Thank you for the opportunity to review the concept plan, for the (Takoma Junction development – SHA Tracking #19-AP-MO-008-xx) in Montgomery County, Maryland. The State Highway Administration (SHA) review is complete and we are pleased to respond.

RE: Preliminary Plan No. 120190150
Takoma Junction
AMENDED LETTER

RE: Preliminary Plan No. 120190150
Takoma Junction
REVISED LETTER

RE: Takoma Junction
Traffic Impact Study Review

MD 195 (Carroll Avenue) at Site Driveway

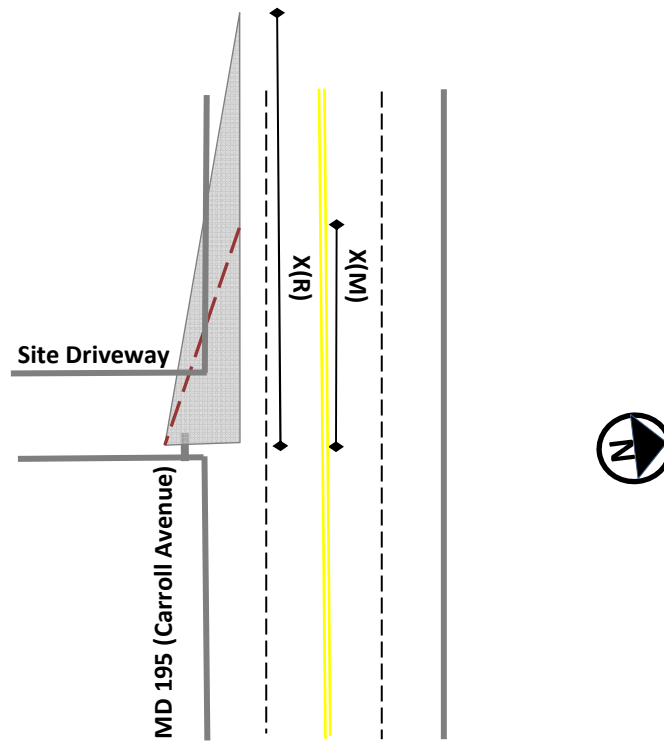
An internal evaluation of the stopping sight distance at the proposed driveway was performed. The results of our analysis are attached. The results show that both intersection and stopping sight distance will not be met at the driveway. Your proposed mitigation may be a deciding factor in our determination of future action on this development.

DATE: 6/3/2021	SHEET NO: 2 of 4
PREPARED BY: SH	REV BY/DATE:
CHECKED BY: AP	REV CHK BY/DATE:
SUBJECT: Stopping Sight Distance Observations Right Turn Maneuver (Eastbound)

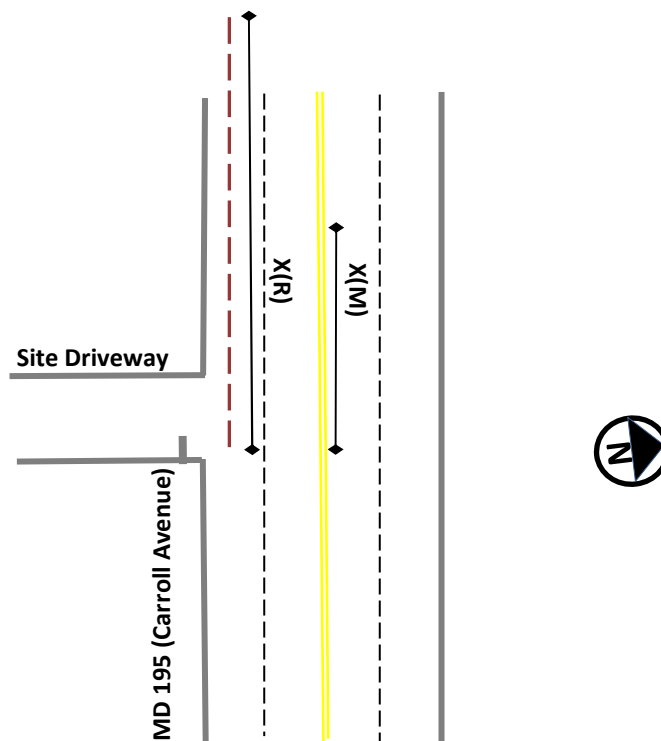
Y Stopping Distance	
X(R) Recommended	250 ft
X(M) Measured	172 ft

Measured stopping sight distance is less than recommended stopping sight distance.
Posted Speed Limit: 25 mph
Prevailing/Design Speed: 35 mph
AASHTO Greenbook, Sight Distance - Case B2: Right Turn from Stop

Figure 2. Stopping Sight Distance Notes

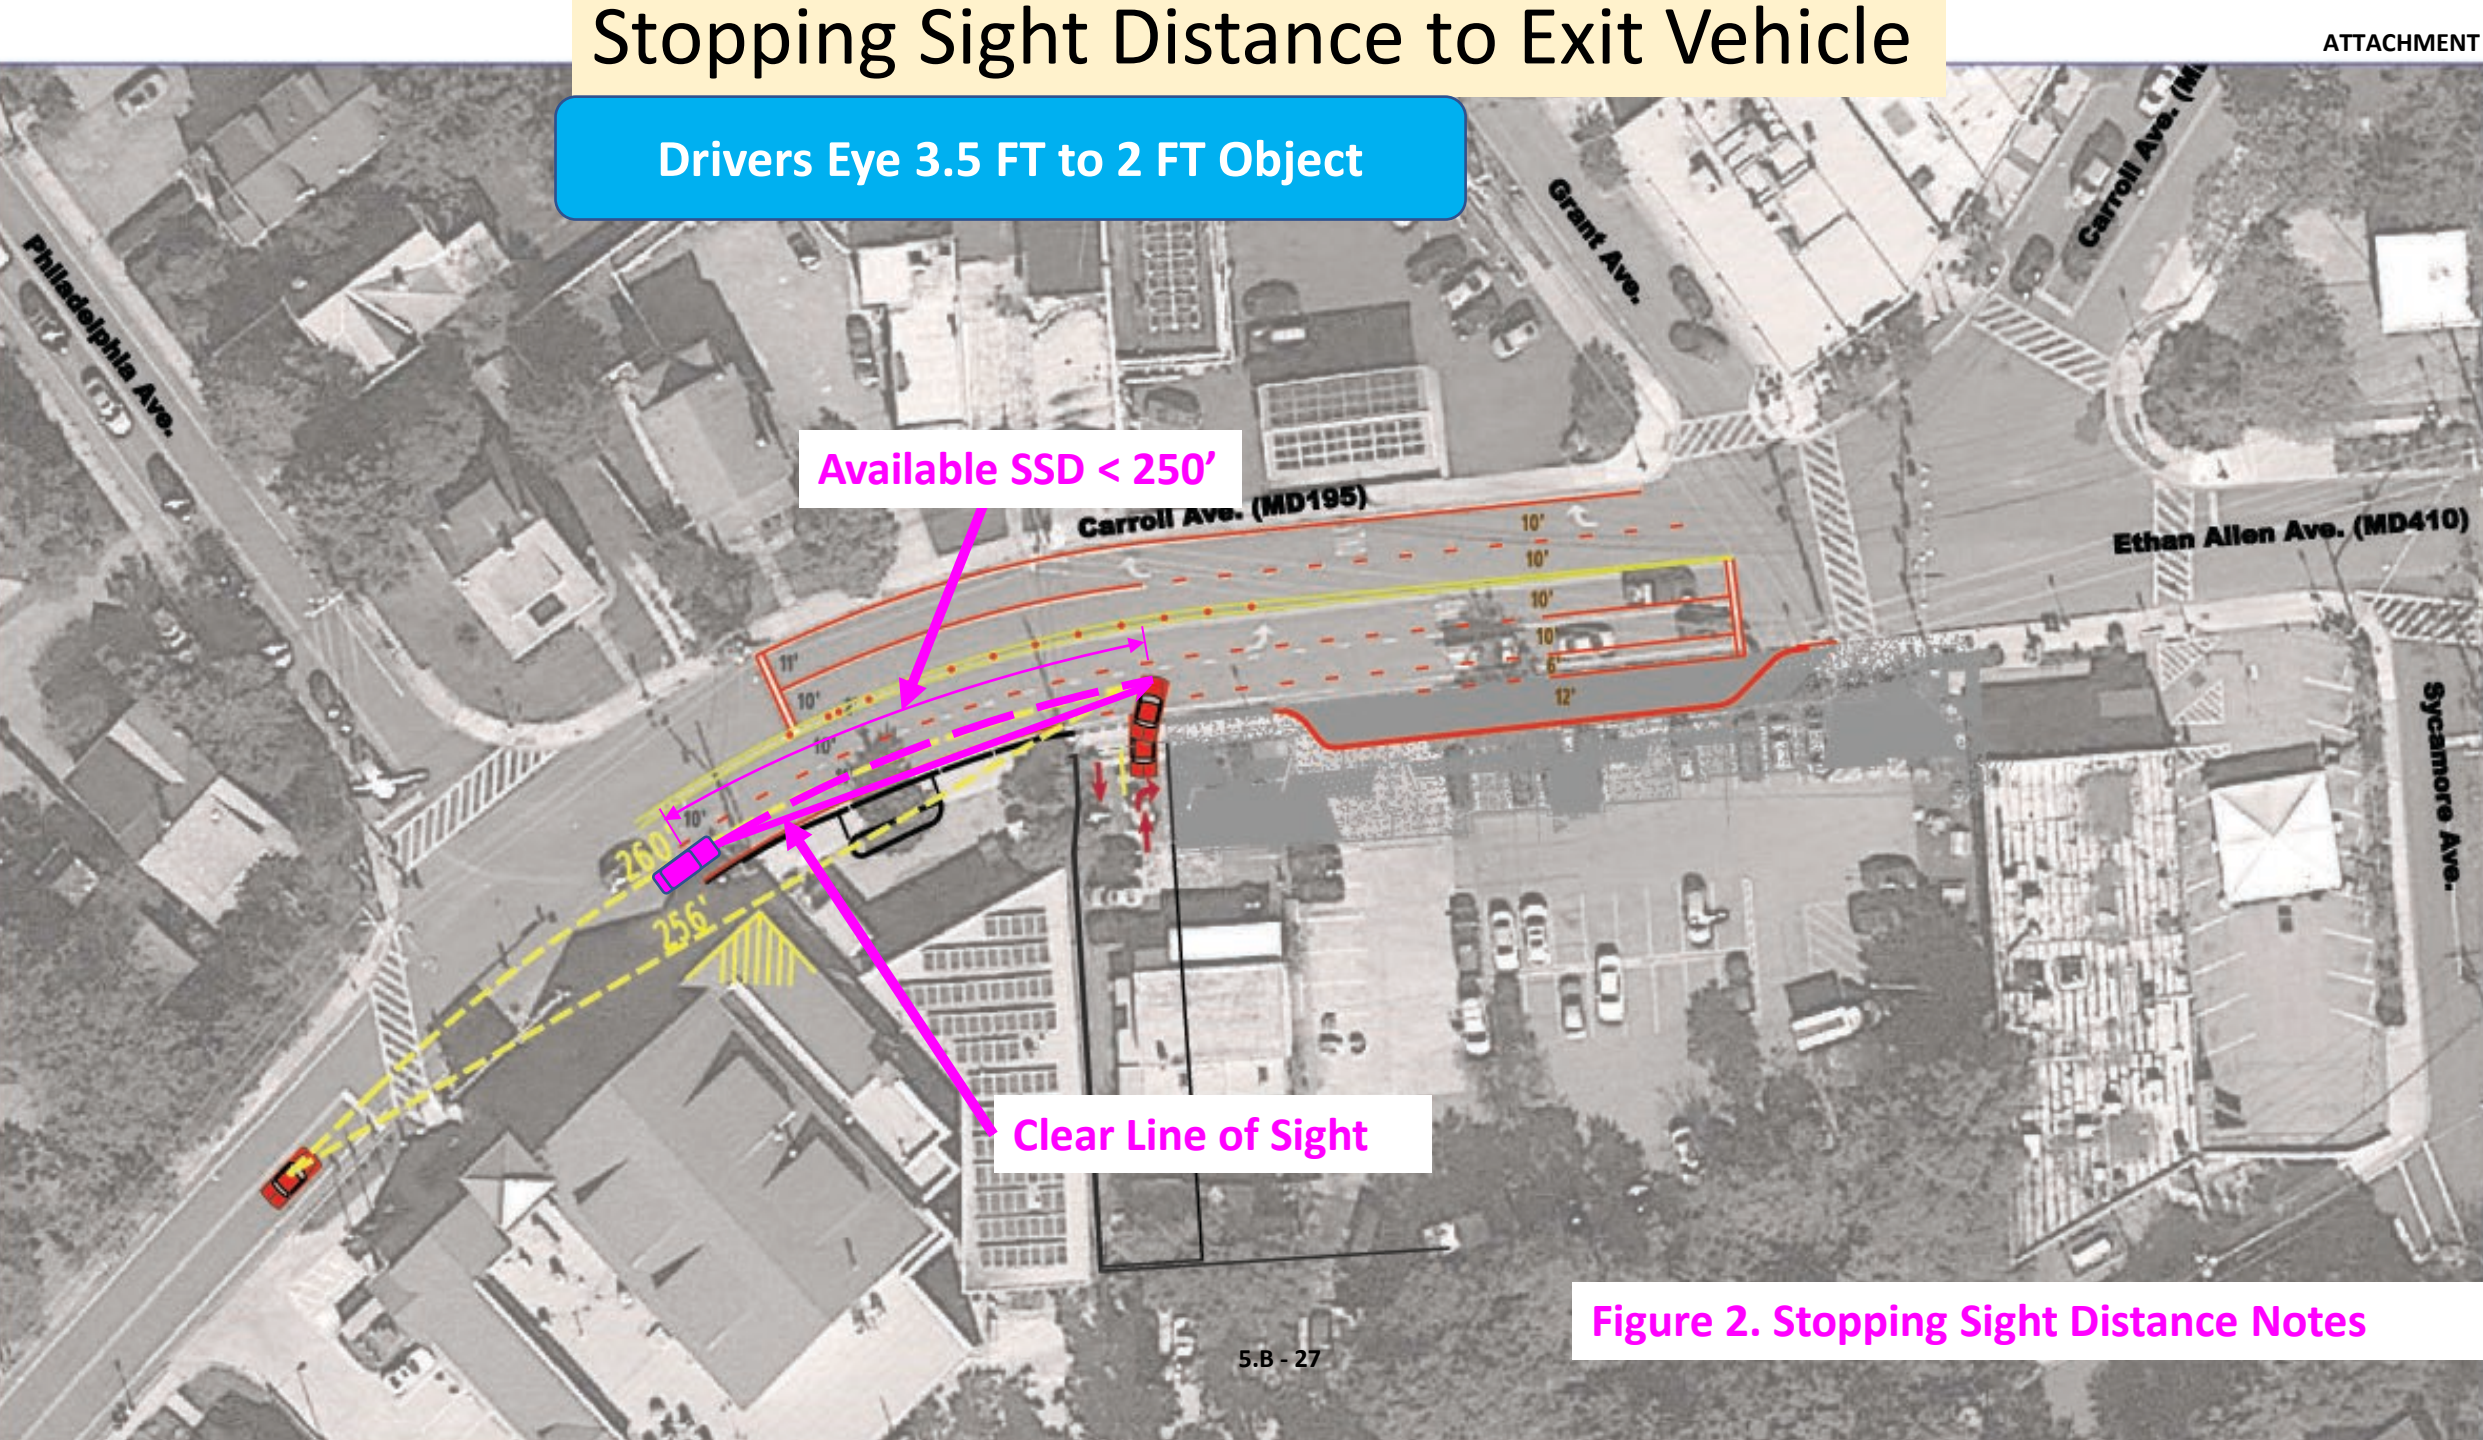
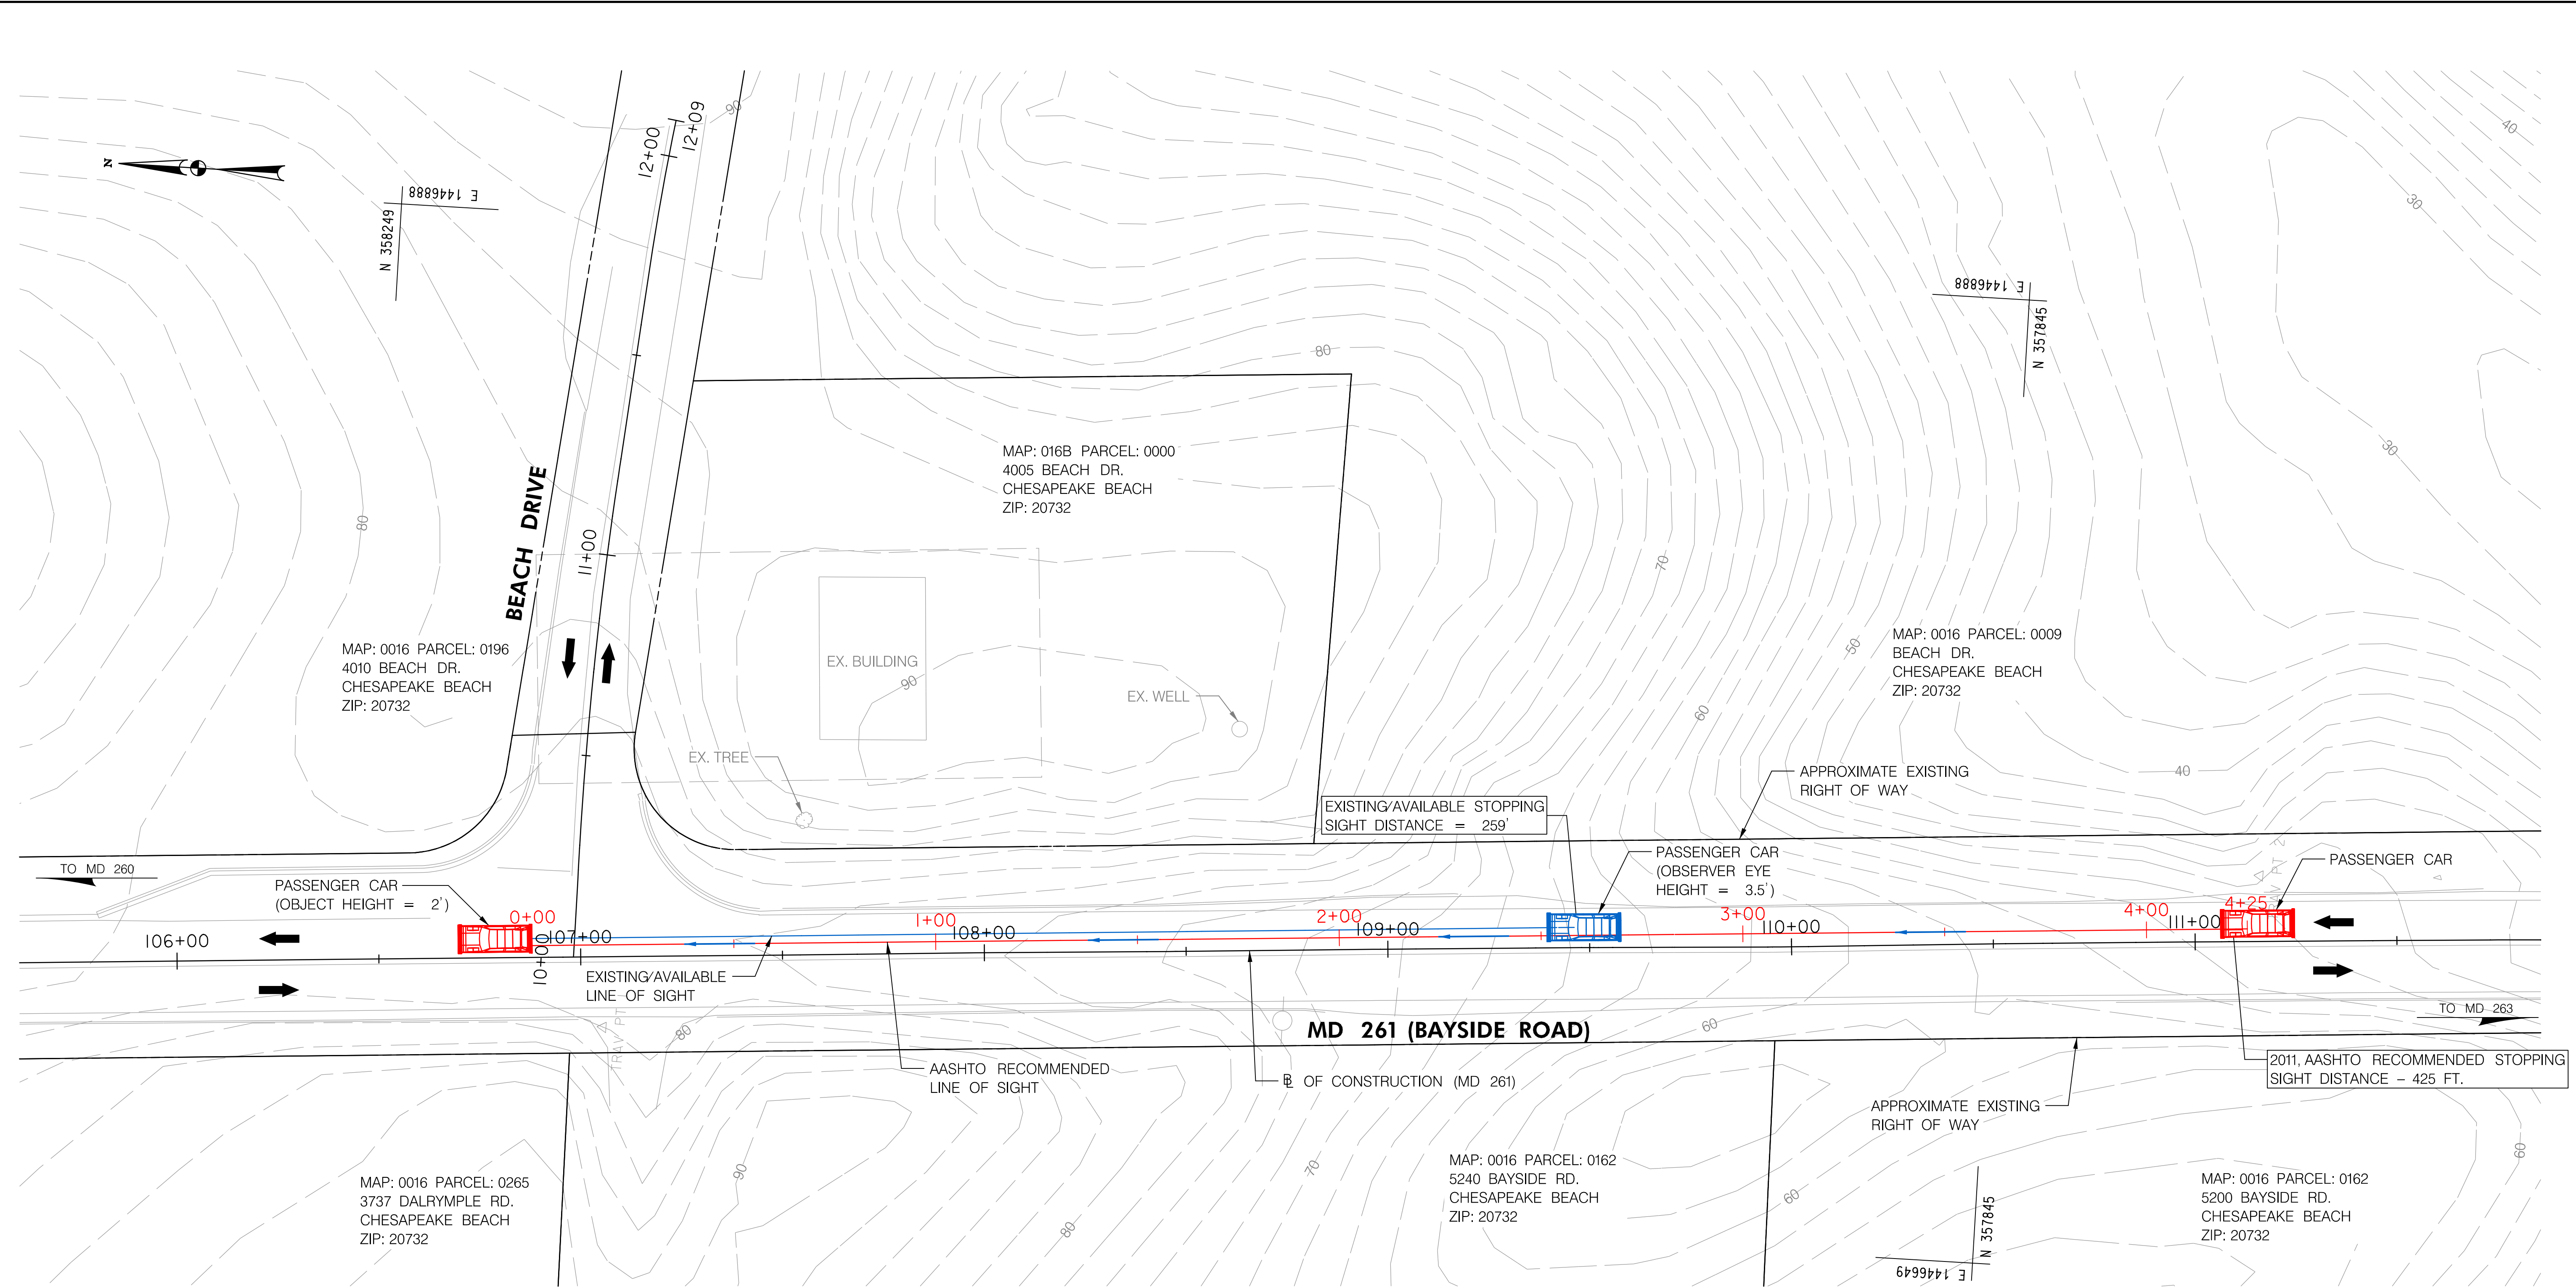
Available SSD < 250'

PROFILE: LINE OF SIGHT
(MD 261 - NORTHBOUND)

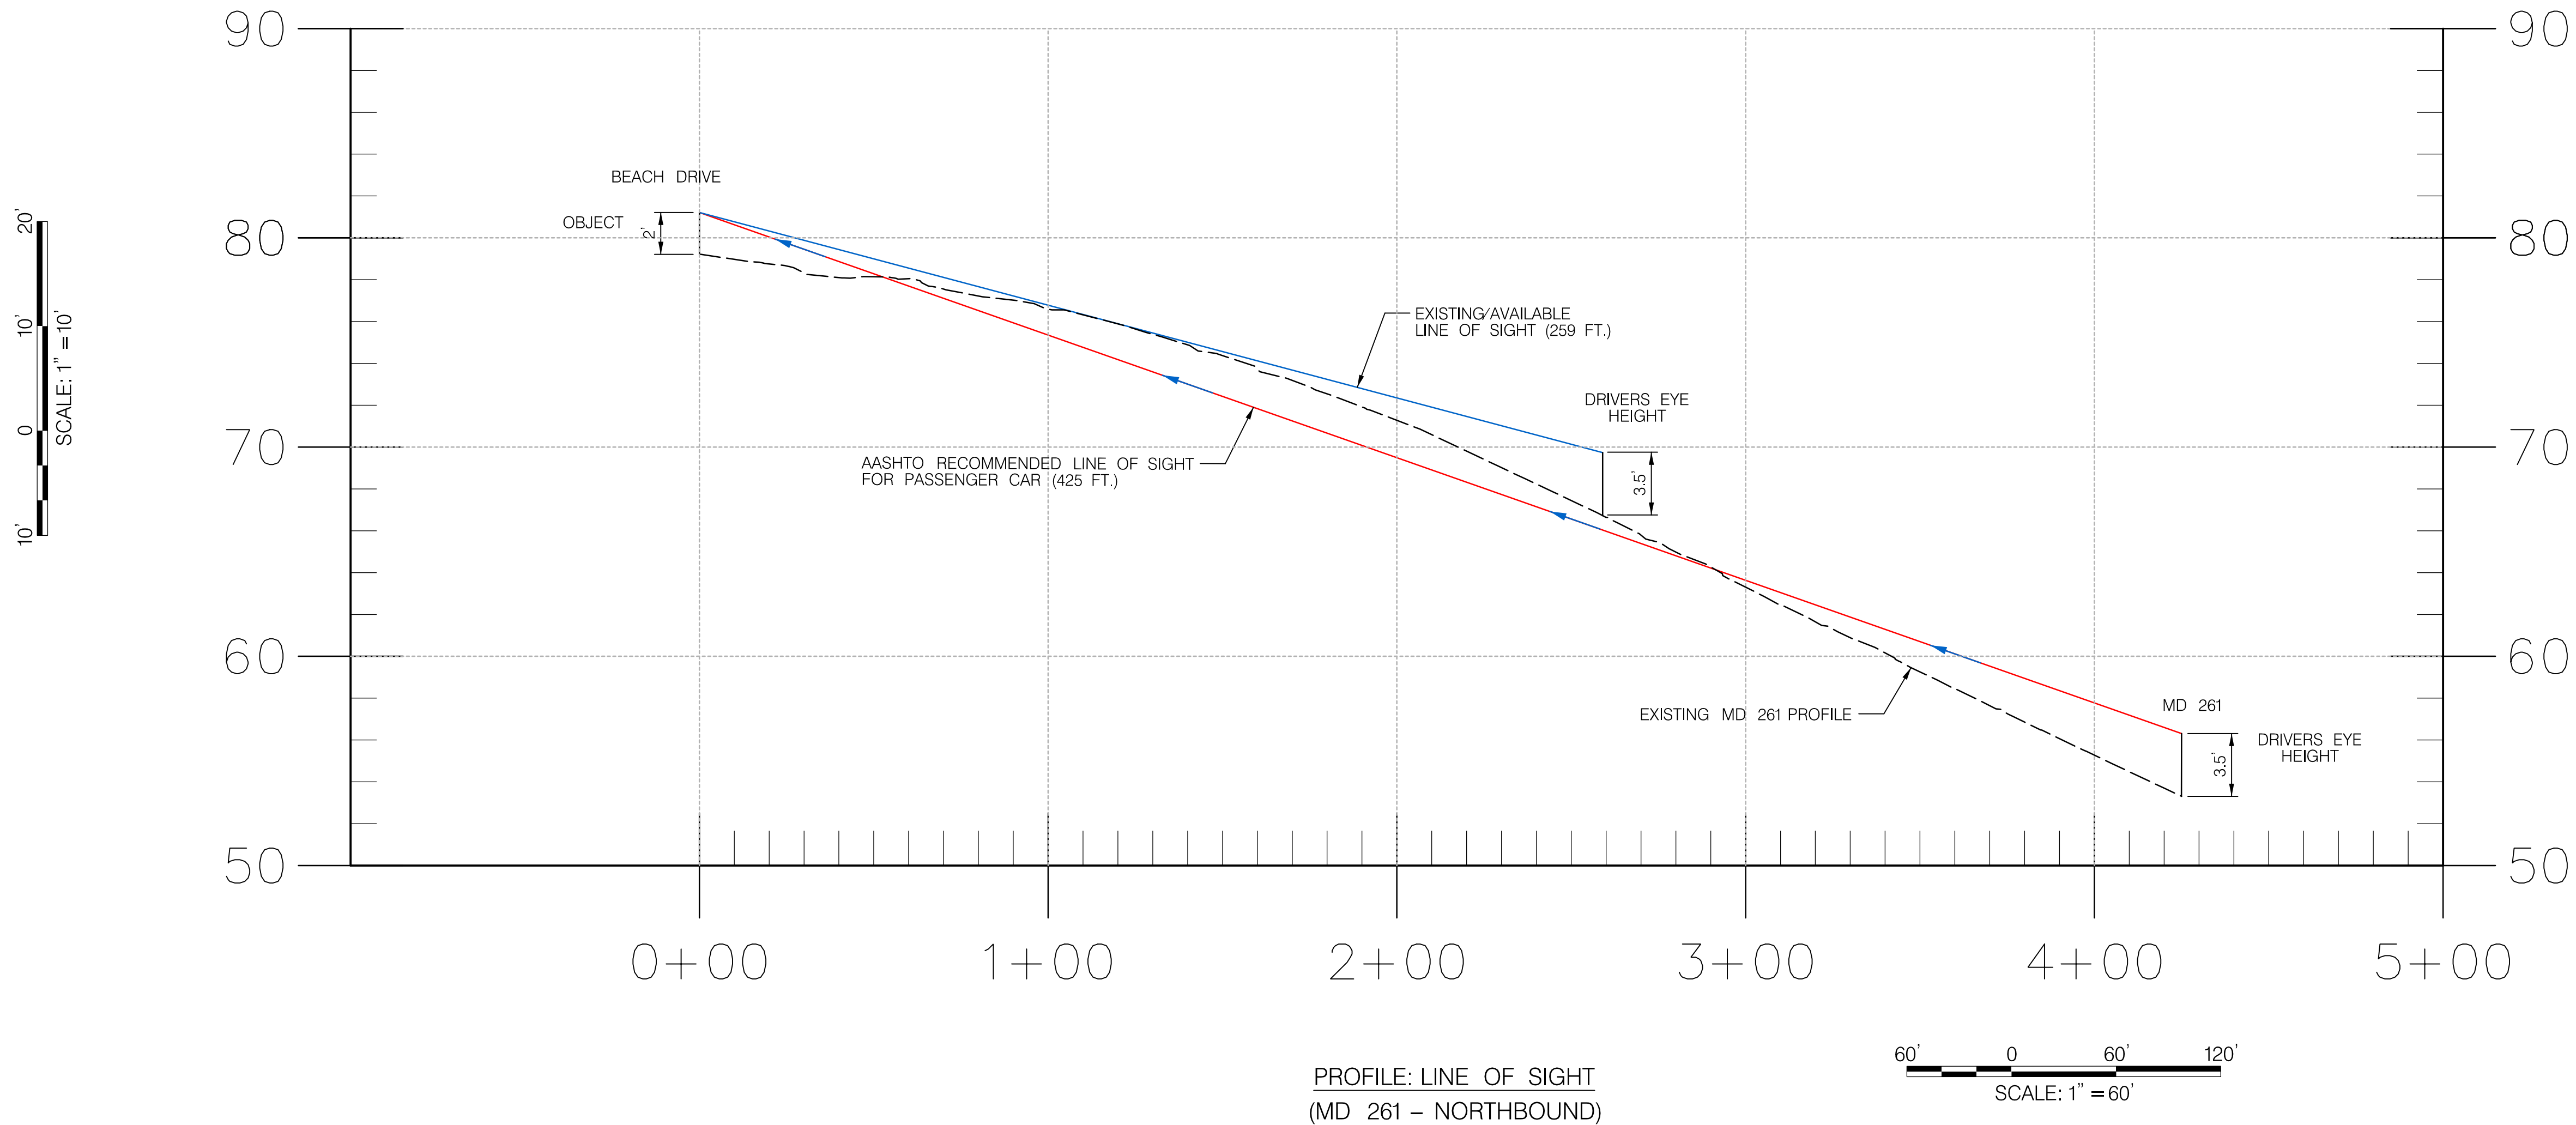
We have attached a sample drawing showing a sight distance profile that may be used to prepare the information requested above. Once the requested information has been received, we will be in a position to review the available sight distances, determine adequacy and what mitigation may be needed, and consider what measures that may be available to address the identified safety concerns.
